Summary of Comments on Serial Attached SCSI 1.1 (SAS-1.1) Standard ■

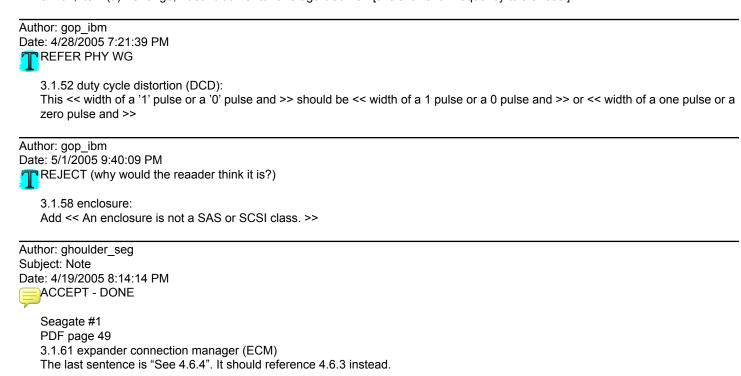
This may not be the correct definition - even as it applies to jitter measurements. It is not cumulative over time, but rather cumulative over a population of jitter measurement samples. Jitter samples are measured as intervals of time, but this definition sounds like it's based on absolute time, not sampled intervals. Suggest:

"The integral of the PDF (see 3.1.143) with limits from negative infinity to a specified jitter value, or from a specified jitter value to positive infinity."

6.8.6.1 State description

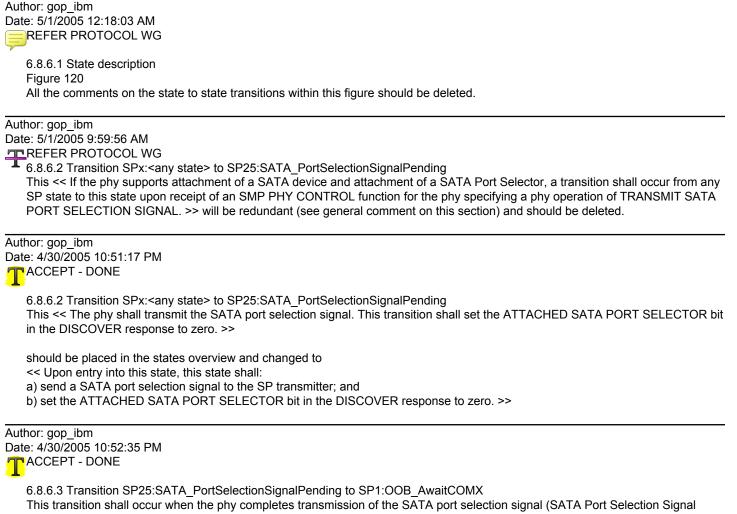
This section is not properly formatted and as such is different that any other state description section is SAS. This has be fixed. a) For one thing there should only be one state shown. The SPx representation is not correct.

b) The SMP Phy Control request should be handled lke the Power on or hard reset or Management Reset request. And it should be placed in all the SP state machine figures not just this one.

REFER PROTOCOL WG (a, b, d: it's pretty clear as shown. Would be messy to add another global into all the other figures. fixed: c unclear: e)
